**Re: Appeal of Preliminary Partition Decision**

*Project Name:* SW 155<sup>th</sup> Avenue 3-Lot Partition  
*Applicant:* ADTM Development, LLC  
*Case File No.:* LD2016-0002, TP2016-0003, FS2016-0001  
*Appeal No.:* APP2016-0003  
*Project Location:* 10510 SW 155<sup>th</sup> Avenue, Tax Lot 00100 of Washington  
County's Tax Assessor's Tax Map 1S132BD

Tract "A" & 3-Lot Partition-10510 SW 155th Ave  
 T: 1S, R: 1W, Sec: 32BD, TL: 100 (EMS 15-0057)  
 Stormwater Sewer Plan

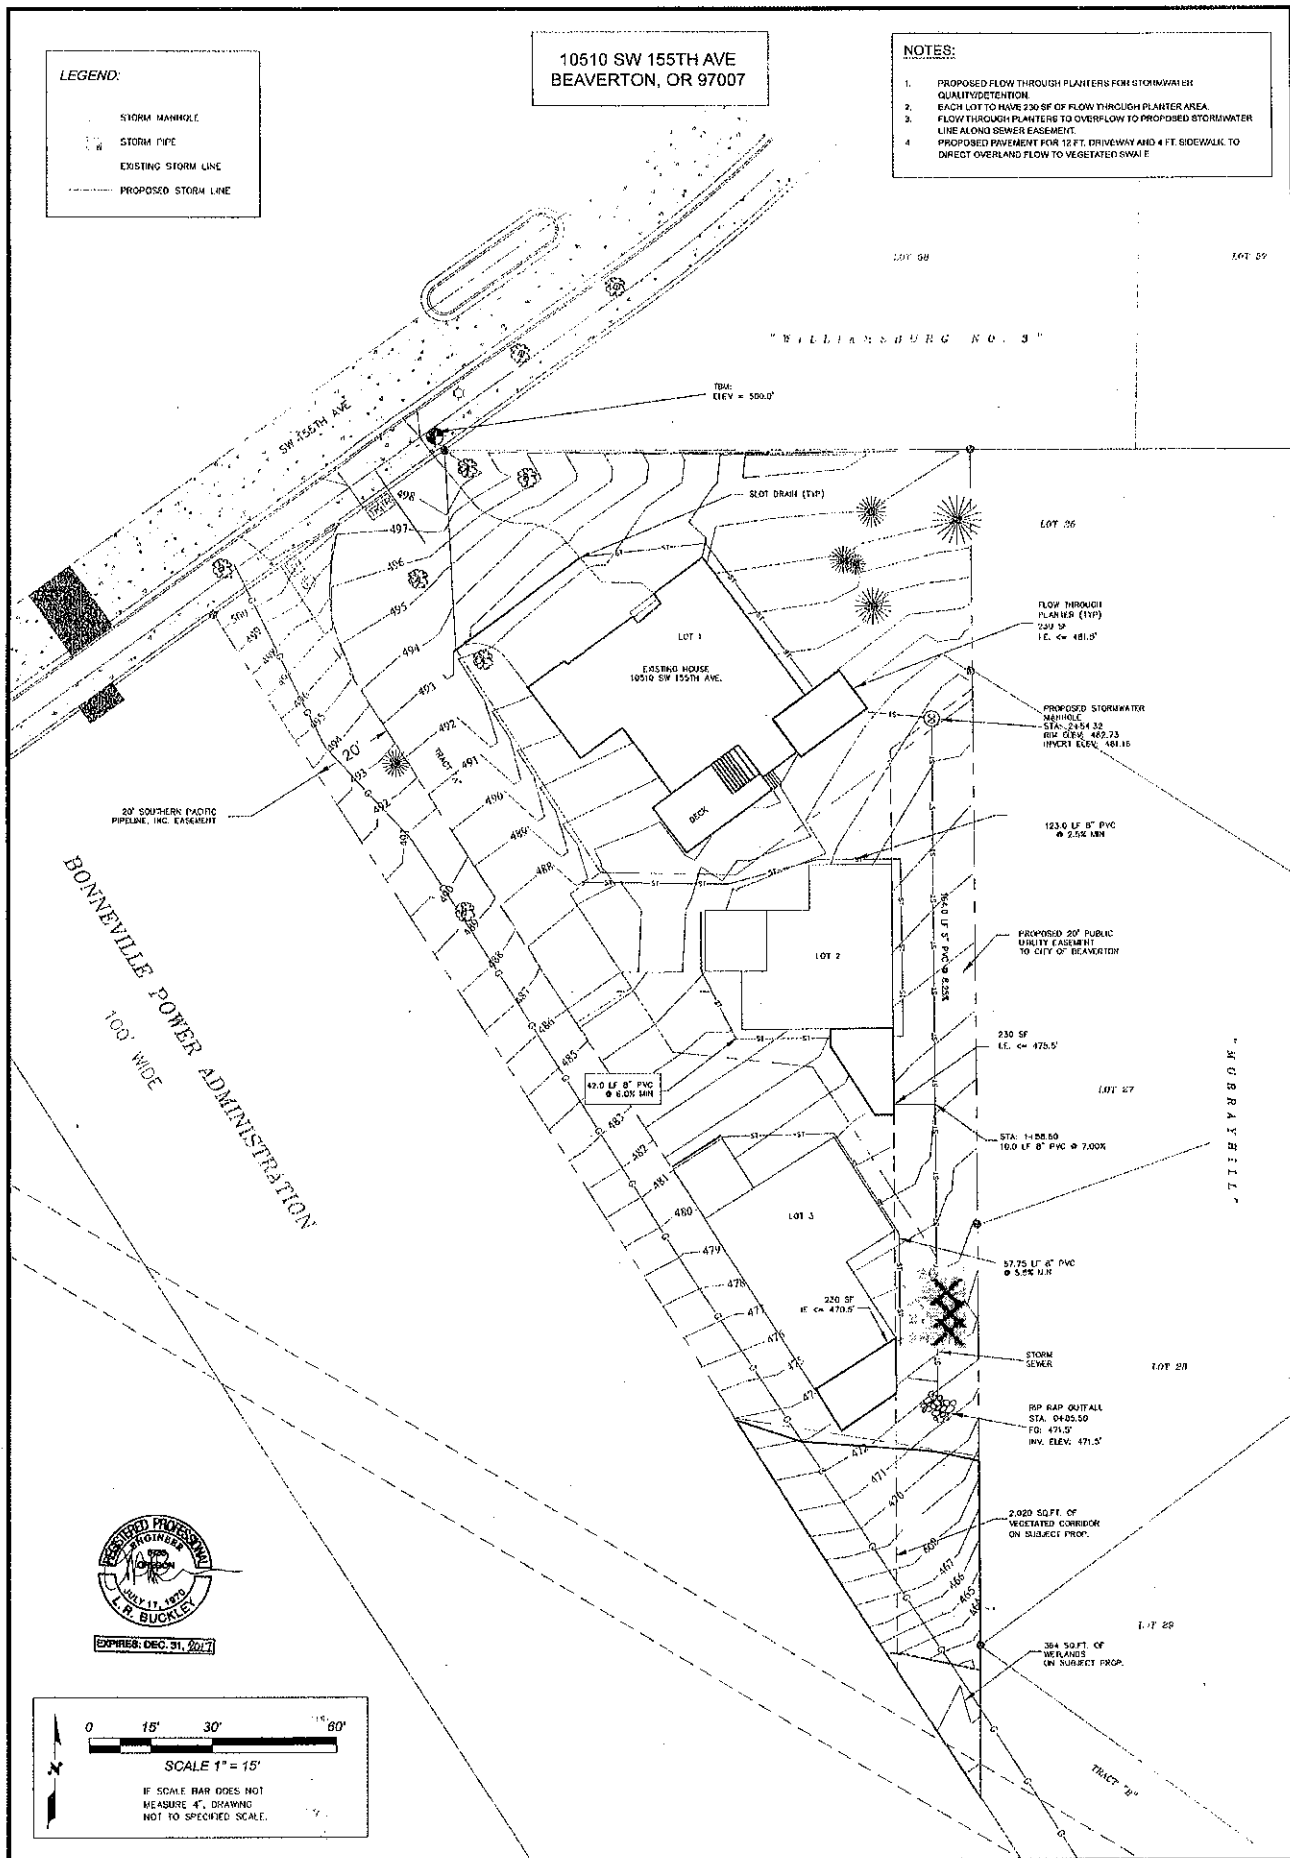
Additionally, it appears that the storm water system, as designed, will prevent the Applicant from saving trees 26, 27, and 28. *See* Ex. 2. Mr. Safestrom indicated that he could save those trees using a boring method to install the storm water system below (without destroying their root systems). However, as designed, the storm sewer line runs at a depth of less than 1.5 feet at that location. *See* Applicant’s Plans p. 10 (showing storm water profile at that location). It seems unlikely that the Applicant will be able to save those trees. Although we appreciate his willingness to save trees, this information brings the accuracy of Mr. Safestrom’s statements into serious question. *See* Ex. 2 (for tree location relative to rip rap outfall), and Applicant Plans, p. 10 (for storm sewer profile). If the rip rap location is moved northward in order to save those trees, it will result in channelized flow directly onto Mr. King’s property. Again, the proposed system presents a serious risk of channelized flow being directed onto Mr. King’s property (as well as onto Lot 28).

Ex. 4

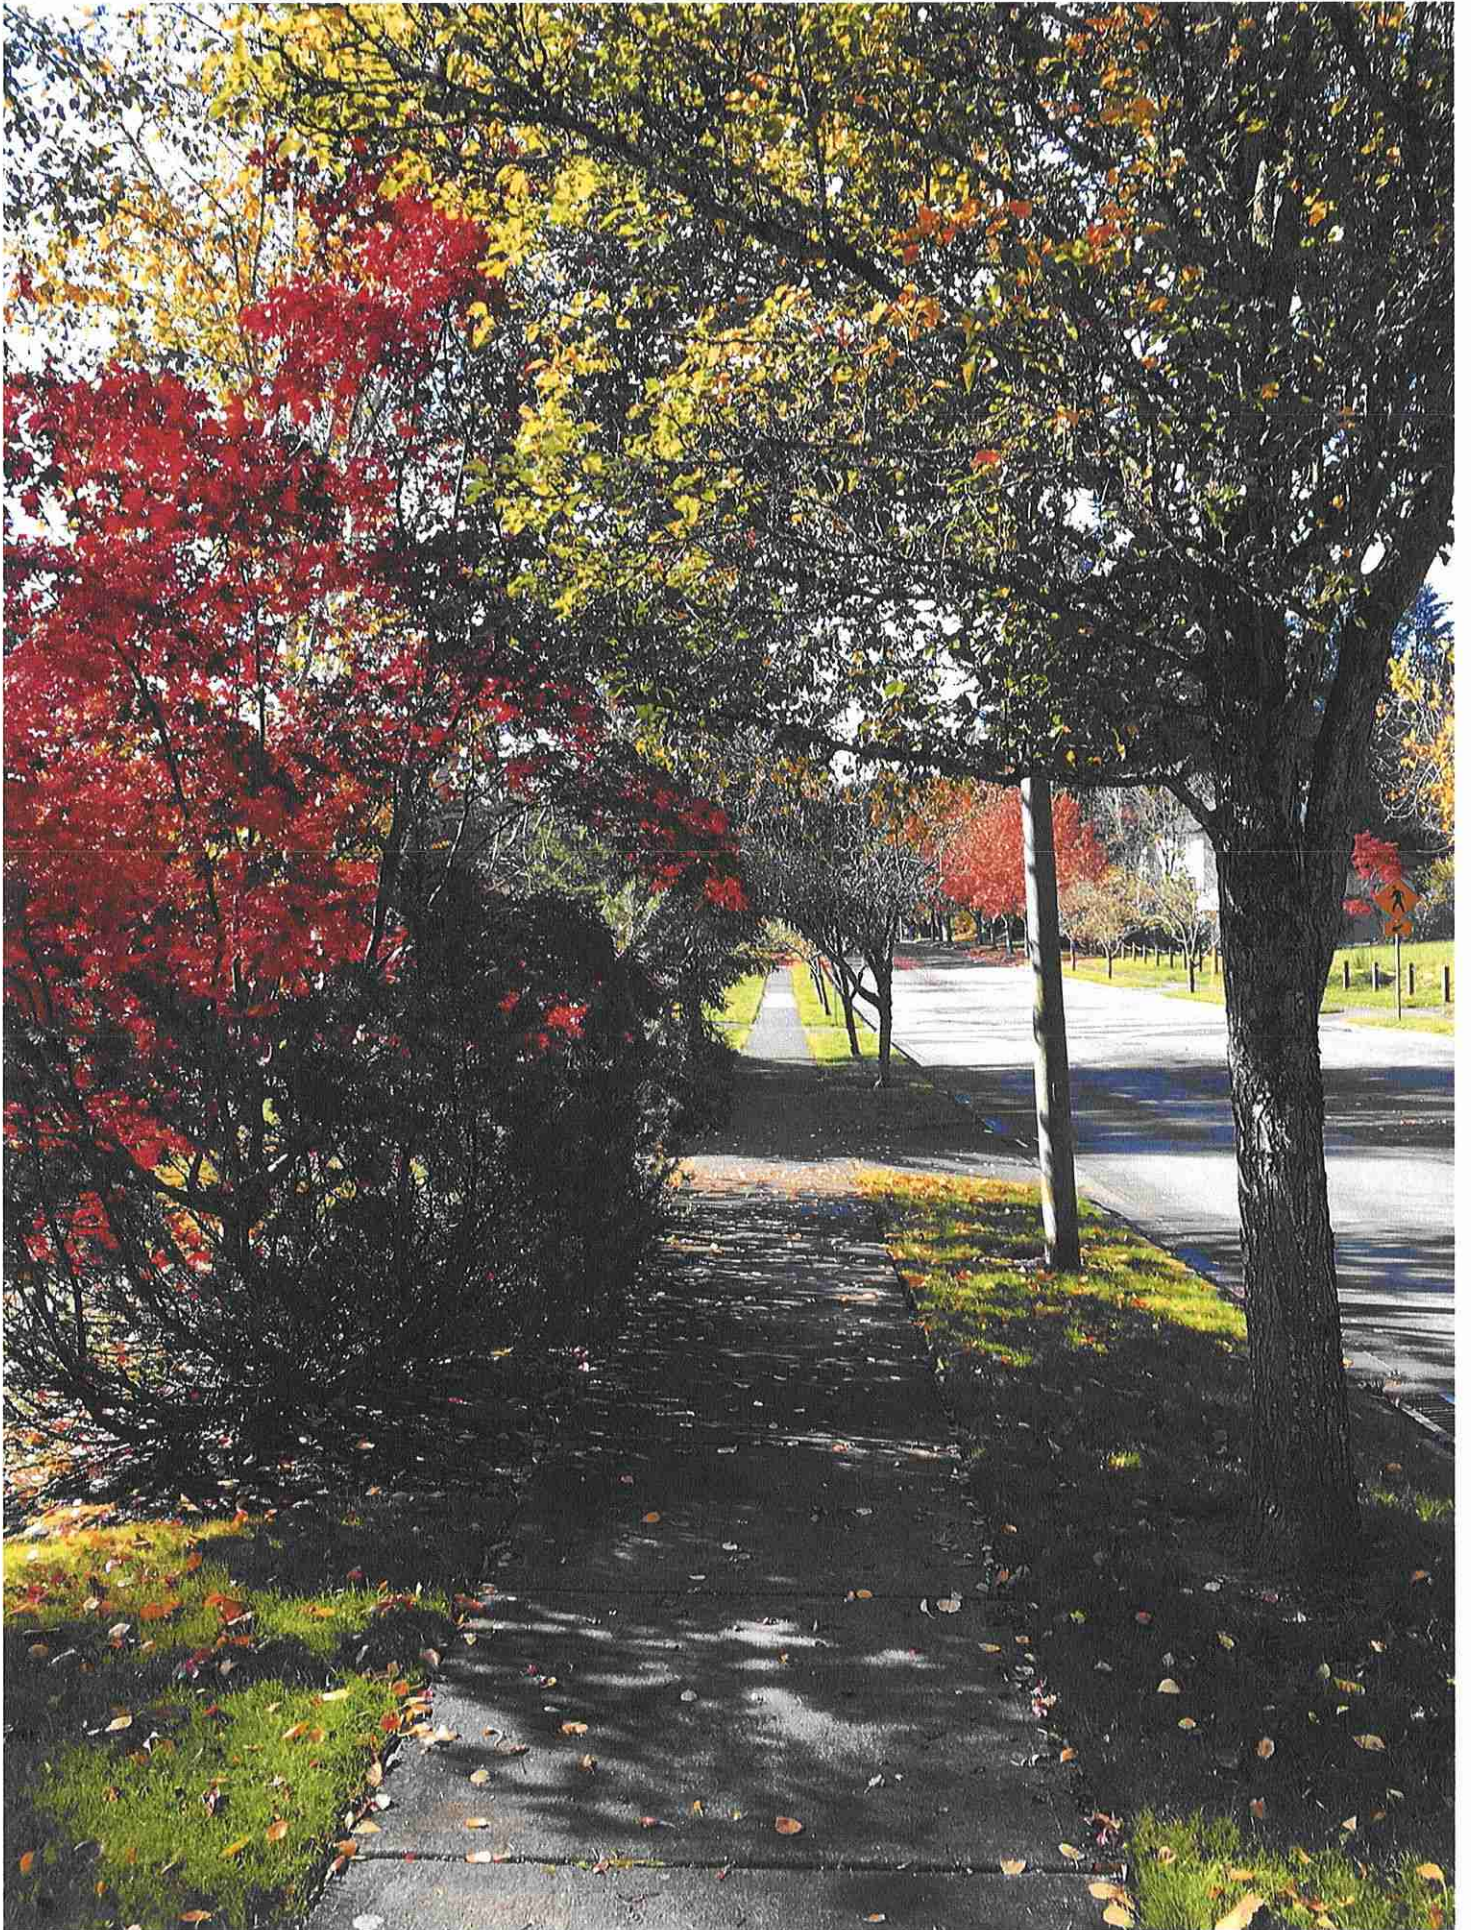
The property has more extensive visibility problems which are set out in the Staff’s Report. There are large bushes and other vegetation on the neighboring property which diminish visibility. *See* Ex. 4 (photo of said vegetation on neighboring property). The planning Staff proposed to alter two conditions of approval which were originally intended to address this unsafe condition. *See* Staff Report, TA-15 (Conditions of Approval No. 21 and 44). As described at the Hearing, the Staff originally was requiring trimming or removal of vegetation to provide a clear sight line. However, it was discovered that much of the offending vegetation is on a neighboring property.

Ex. 7

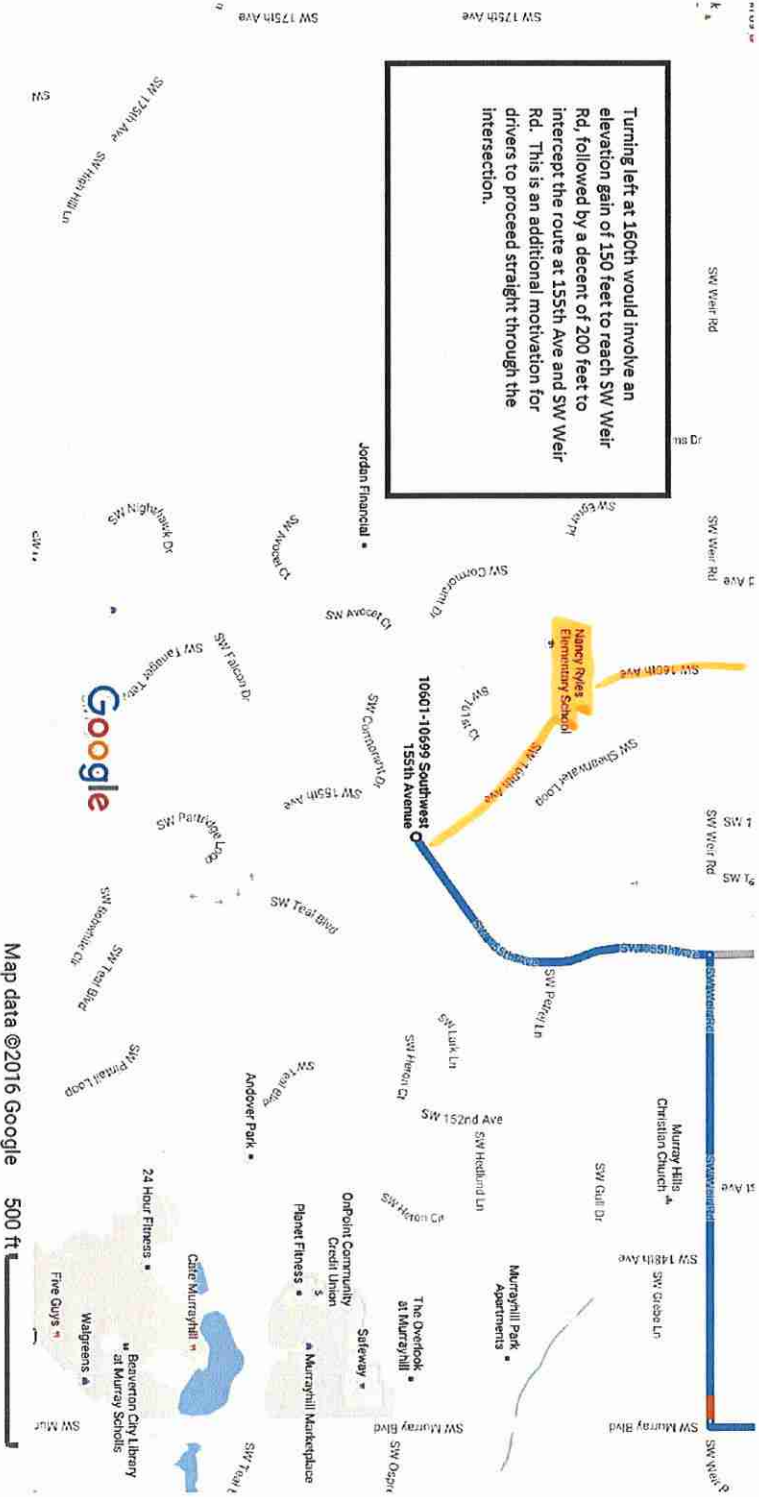
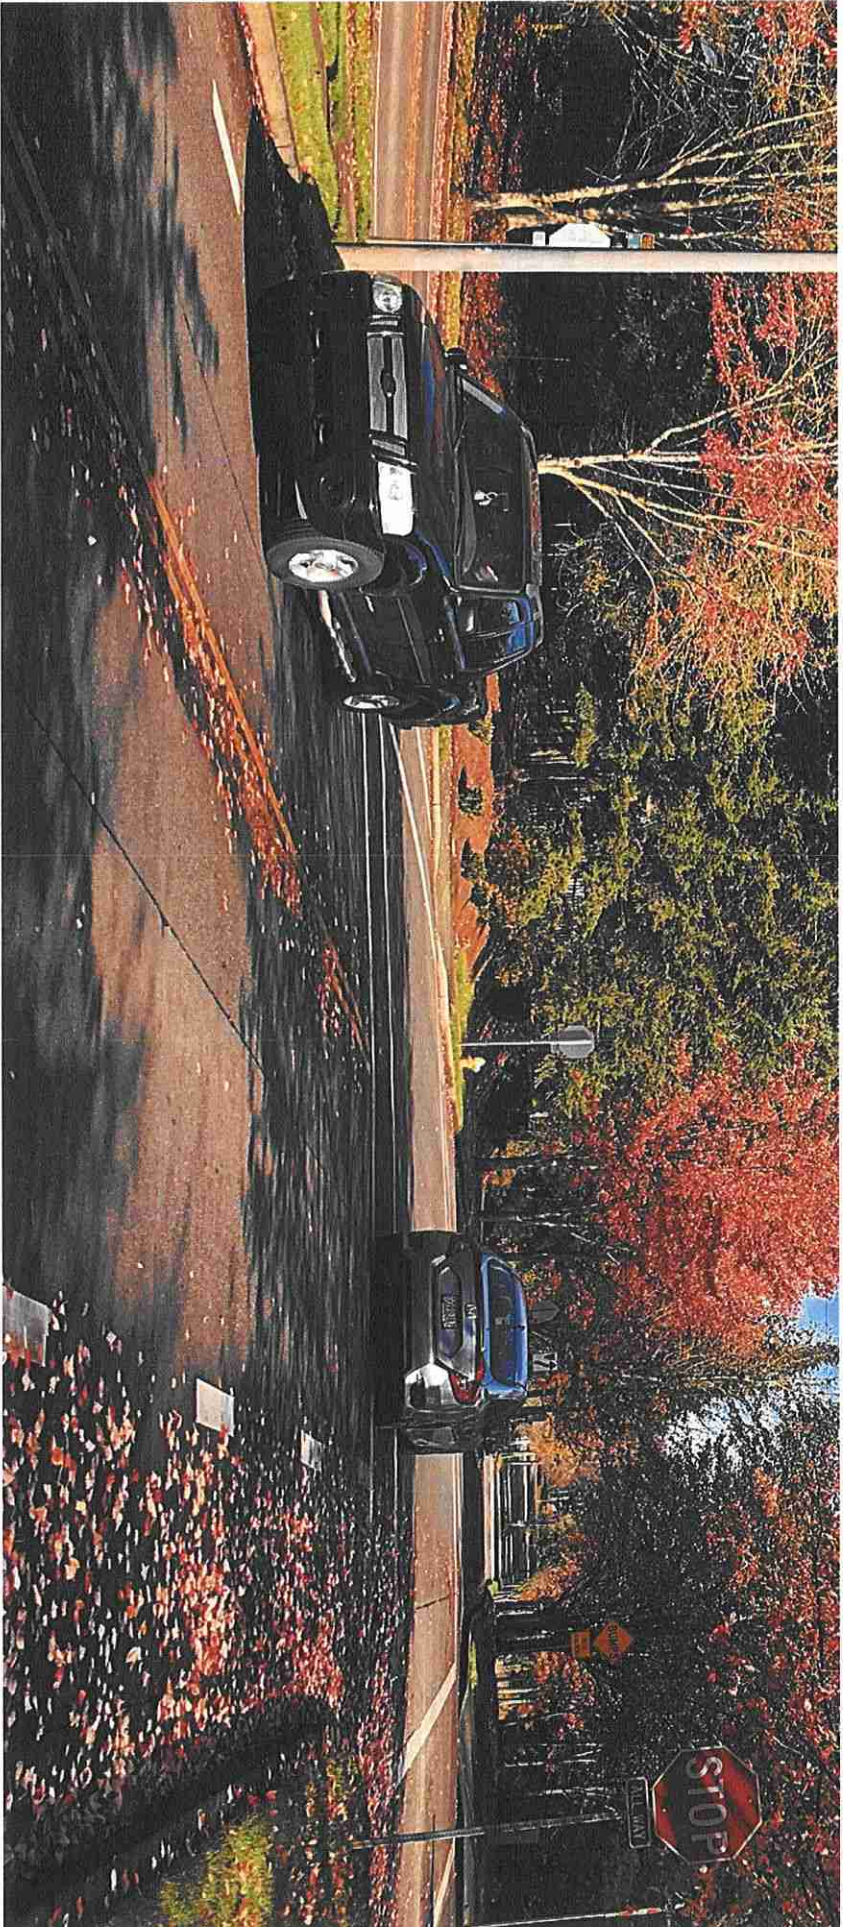
In order for 155<sup>th</sup> Avenue to be a “neighborhood route,” the majority of traffic leaving the neighborhood would be required to turn left at the intersection of 155<sup>th</sup> Avenue and 160<sup>th</sup> Avenue, another collector route within Murrayhill. *See* Ex. 7 (map). The City has installed a sign and speed bumps along 155<sup>th</sup> Avenue past that intersection to encourage drivers to turn left on 160<sup>th</sup> Avenue (to continue on to Weir Road). *See* Ex. 8 (photo of intersection). Mr. King and surrounding home owners have observed that drivers generally do not follow the expected or encouraged traffic pattern. Rather, the vast majority of drivers continue driving on 155<sup>th</sup> Avenue, and cross in front of the subject property on their way to Weir Road.

Google maps and similar navigation programs direct drivers to do just that. *See* Ex. 7 (showing Google Maps’ selection for the best route to take through the neighborhood to get to City Hall.) That route passes directly in front of the subject property. Drivers also do not take the SW 160<sup>th</sup> Avenue route because it is particularly hilly. Given all of the above, the appellant requests that the City conduct a traffic study at the intersection of 155<sup>th</sup> Avenue and SW 160<sup>th</sup> Avenue to verify actual driver behavior, and determine if the classification of 155<sup>th</sup> Avenue as a “neighborhood route” is accurate.

Turning left at 160th would involve an elevation gain of 150 feet to reach SW Weir Rd, followed by a descent of 200 feet to intercept the route at 155th Ave and SW Weir Rd. This is an additional motivation for drivers to proceed straight through the intersection.
